Access Compliance Report Public Rights-of-Way (Pedestrian Signals)

Main Street: UNIVERSITY_DR Cross Street: IRVINE_AVE Location: N

ADA ID: SGRK211018115131 Signal Type: One Push Button-Non APS Overall Compliance: No Severity Scores: BTN 1: 10 BTN 2: N/A No BTN: N/A

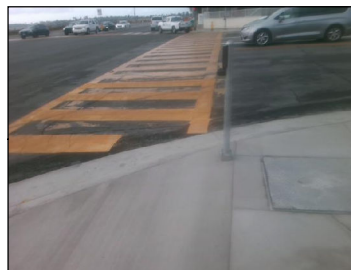
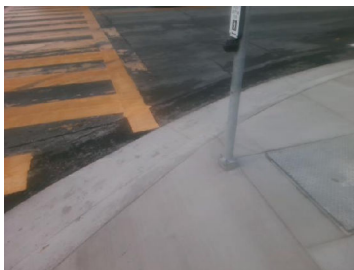
N/A Is Button 1 APS or Non-APS?	NonAPS	N/A Is Button 2 APS or Non-APS?	N/A
N/A B 1 VibroTact Arrow?	N/A	N/A B 2 VibroTact Arrow?	N/A
N/A B 1 VibroTact Parallel to Xing?	N/A	N/A B 2 VibroTact Parallel to Xing?	N/A
N/A B 1 VibroTact Contrast	N/A	N/A B 2 VibroTact Contrast	N/A
No B 1 Pilot Light?	No	N/A B 2 Pilot Light?	N/A
N/A B 1 Pilot Light Illumination?	N/A	N/A B 2 Pilot Light Illumination?	N/A
N/A B 1 Walk Indicator Type	N/A	N/A B 2 Walk Indicator Type	N/A
N/A B 1 Walk Indicator Audible?	N/A	N/A B 2 Walk Indicator Audible?	N/A
N/A B 1 Locator Tone?	N/A	N/A B 2 Locator Tone?	N/A
N/A B 1 Tone Audible Range?	N/A	N/A B 2 Tone Audible Range?	N/A
B 1 Addl APS Features?	No	B 2 Addl APS Features?	N/A
B 1 Addl APS Features Notes	N/A	B 2 Addl APS Features Notes	N/A

Possible Solutions: Replace Signal Push Button With APS Button.
